**BOARD OF ZONING ADJUSTMENT
STAFF REPORT****Date: April 6, 2015****CASE NUMBER**

5919/5866

New Cingular Wireless PCS, LLC

LOCATION6311 Cottage Hill Road
(220'± South of Cottage Hill Road, 780'± East of Hillcrest Road)**VARIANCE REQUEST****HEIGHT:** Height Variance to allow a 150' monopole telecommunications tower in a B-2, Neighborhood Business District.**SETBACK:** Setback Variance to allow the tower within 37.5' of the lease parcel line.**RESIDENTIAL BUFFER SEPARATION:** Residential Buffer Separation Variance to allow the tower within 42.75' of residentially zoned property.**TREE PLANTING:** Tree Planting Variance to allow no tree plantings.**ZONING ORDINANCE
REQUIREMENT****HEIGHT:** The Zoning Ordinance limits structures to a 45' height in a B-2, Neighborhood Business District.**SETBACK:** The Zoning Ordinance requires telecommunications towers to be setback the height of the tower (150') from the lease parcel line.**RESIDENTIAL BUFFER SEPARATION:** The Zoning Ordinance requires a residential buffer separation of 200' or 150% of the height of the tower, whichever is greater (225').**TREE PLANTING:** The Zoning Ordinance requires one tree per every 30' of lease parcel perimet

DETAIL SITE PLAN

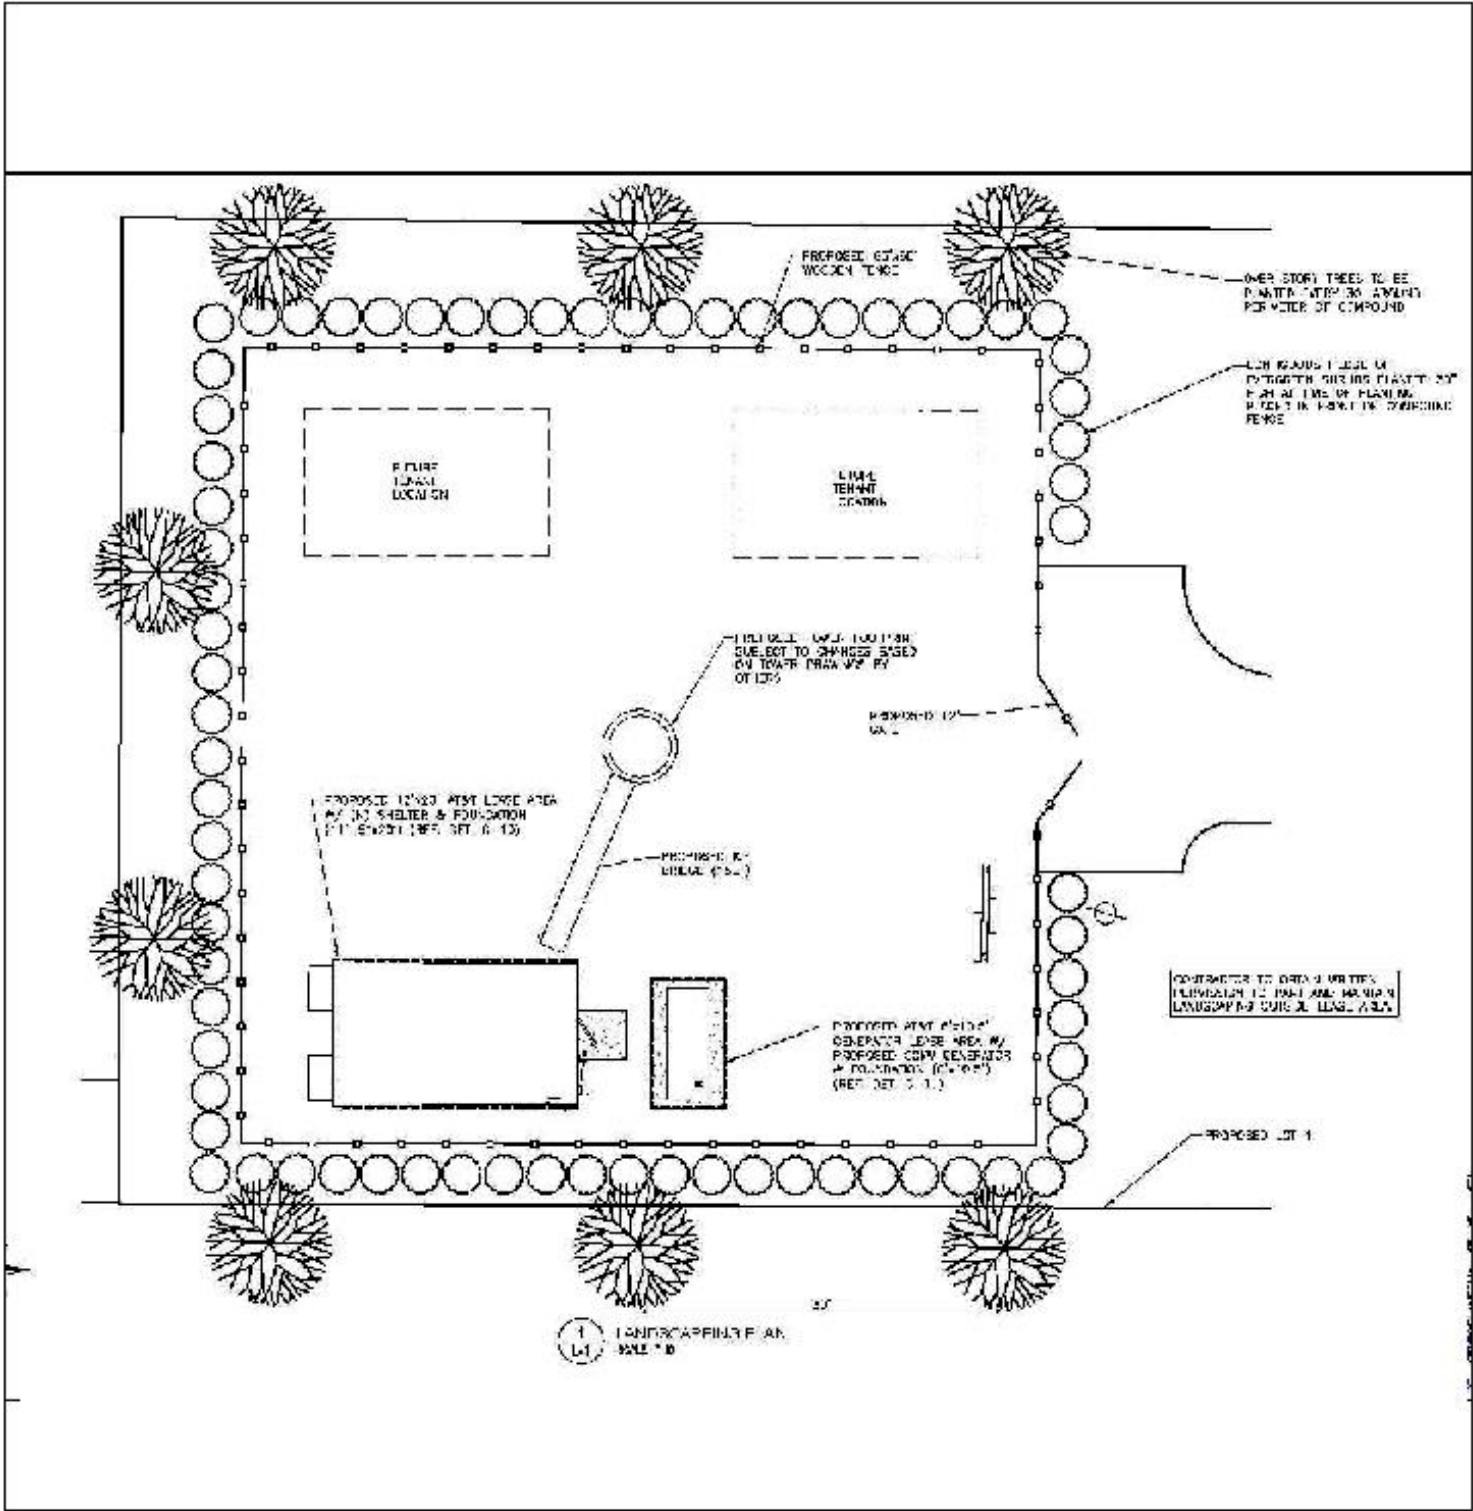
With regard to the Setback and Residential Buffer requests, the applicant states that the requirement to meet the Zoning Ordinance provisions for setbacks and residential buffer present a specific unnecessary hardship due to the constraints of the small parcel. It is stated that neither of these hardships is economic in nature or self-imposed by the applicant and it is believed that the proposal to place the proposed tower within a wooded area on the property best serves the need to provide the least visually obtrusive alternative. As the site is limited in area by surrounding properties, a hardship is illustrated in meeting the required lease parcel setbacks and the Setback Variance request would be justified. And as the technical data submitted supports the selection of this location for the proposed tower, and as a hardship in meeting the Residential Buffer Separation requirement is imposed by the site's location, the Residential Buffer Separation Variance would be justified. Although the closest residentially-zoned property is a cemetery approximately 43' North of the proposed tower, a single-family residential subdivision is located approximately 145' South of the proposed tower. Due to the proximity of the residential property to the South, the applicant has proposed a 6' wooden privacy fence around the tower compound. However, the site plan should be revised to indicate an 8' high fence as required by the Chart of Permitted Uses of the Zoning Ordinance.

The site plan submitted indicates a contiguous hedge of evergreen shrubs around the tower compound and eight overstory trees beyond. However, the three trees indicated to the South of the compound are actually indicated to be on the adjacent separate proposed lot to the South. Therefore, only five overstory trees are indicated as actually proposed on the tower site, and the lot perimeter would require twelve overstory trees. The applicant bases the Tree Planting Variance request based on the proposed site mostly being surrounded by existing mature trees. However, some trees would have to be removed to develop the tower site and no hardship has been illustrated to justify the granting of the Tree Planting Variance request, especially in light of the fact that sufficient area would be provided by the clearing for the tower lease parcel to provide the required number of trees.

- 1) the tower is limited to a monopole design with an over-all height of 150', including the antenna extension and the lightning rod;
- 2) revision of the tower elevation to indicate that no communications equipment or lightning rod extends above the 150' elevation above grade;
- 3) revision of the site plan to indicate an 8' high wooden privacy fence around the tower compound as required by the Chart of Permitted Uses of the Zoning Ordinance;
- 4) provision of further overstory trees within the lot perimeter to be coordinated with the Planning Division of the Urban Development Department;
- 5) subject to the Planning Commission approval of the Planning Approval and two-lot Subdivision applications; and
- 6) full compliance with all municipal codes and ordinances.
